<b>Title of Change:</b>	Added comments and corrected typos in LV8907UWR2G datasheet and application note.	
<b>Effective date:</b>	1 July 2019	
<b>Contact information:</b>	Contact your local ON Semiconductor Sales Office or <Kei.Nagai@onsemi.com>	
<b>Type of notification:</b>	This Product Bulletin is for notification purposes only. ON Semiconductor will proceed with implementation of this change upon publication of this Product Bulletin.	
<b>Change Category:</b>	<input type="checkbox"/> Wafer Fab Change <input type="checkbox"/> Assembly Change <input checked="" type="checkbox"/> Test Change <input checked="" type="checkbox"/> Other <u>Added comments in datasheet and application note</u>	
<b>Change Sub-Category(s):</b>	<input type="checkbox"/> Manufacturing Site Addition <input type="checkbox"/> Material Change <input checked="" type="checkbox"/> Datasheet/Product Doc change <input type="checkbox"/> Manufacturing Site Transfer <input type="checkbox"/> Product specific change <input type="checkbox"/> Shipping/Packaging/Marking <input type="checkbox"/> Manufacturing Process Change <input type="checkbox"/> Other: _____

Figure 5. Example Waveform

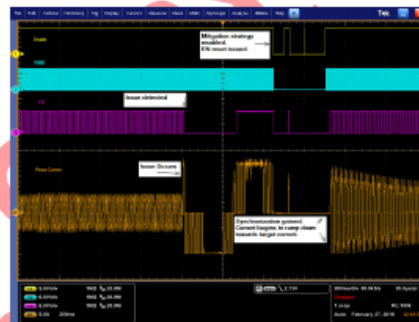
Figure 5 shows example waveform in the case that the commutation synchronization is lost. The coil current (Orange plot) shows abnormally high currents. FG pulse period changes drastically.

Figure 5 also shows example waveform of resynchronization by toggling EN pin. The EN pin should be set low immediately when incoherent FG pulse detected in an actual application.

The FG pulse must be monitored. When the loss of commutation synchronization is detected by the abnormal FG pulse train described above, LV8907UW must be restarted. By setting the rotation enable pin, EN, to a logical low state, the driver output is deactivated to halt the over current situation. After this deactivation, the pin EN should be set logical high to restart. The LV8907UW will enter its normal startup sequence and regain synchronization. To enable this resynchronization of LV8907UW, the register bit named FRREN must be set 0. (See [datasheet](#) for detail).

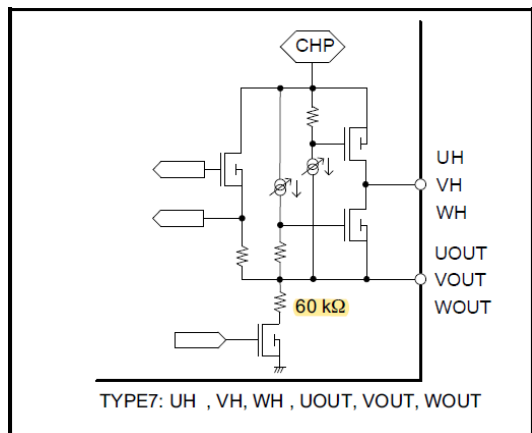
**9. A metric prefix kilo must be lowercase.**

The charge pump circuit operates nominally at 52.1 **KHz**.  
 A SSCG function is provided to add a spread-spectrum component for EMI reduction.
